NEW MEXICO OIL CONSERVATION DIVISION

Request for Administrative Approval of Unorthodox Oil Well Location and Simultaneous Dedication

Brunson-Eaves Lease Line #1 (Formerly Rollon Brunson #7) 1460' FNL & 1330' FEL, SW/4 NE/4 of Section 10, T22S, R37E, Unit Letter G Lea County, New Mexico

Subject: Chevron NSL Application: Brunson Eaves Lease Line #1

Exhibit 3.1

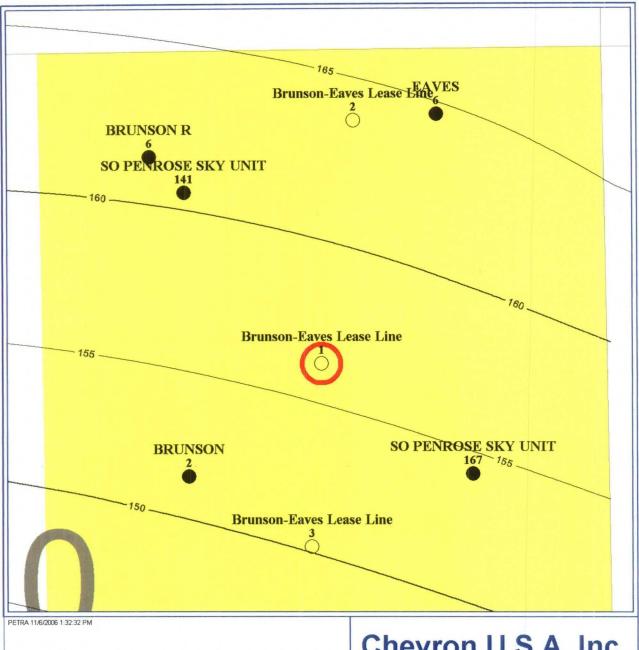
However that statement seems at variance with the attached plat (Exhibit 3.1) which shows two leases, the Brunson lease and the Eaves lease.

However that statement seems at variance with the attached plat (Exhibit 3.1) which shows two leases, the Brunson lease and the Eaves lease.

In regards to our conversation on Monday, December 11th about the Brunson Eaves Lease Line wells...we have a verbal agreement with both of the land owners. We are waiting for the signed agreement to be sent back this week. When I receive it, I will forward it on to you. If you have any further questions on any of the applications, please don't hesitate to e-mail me or call at (281) 661-3773.
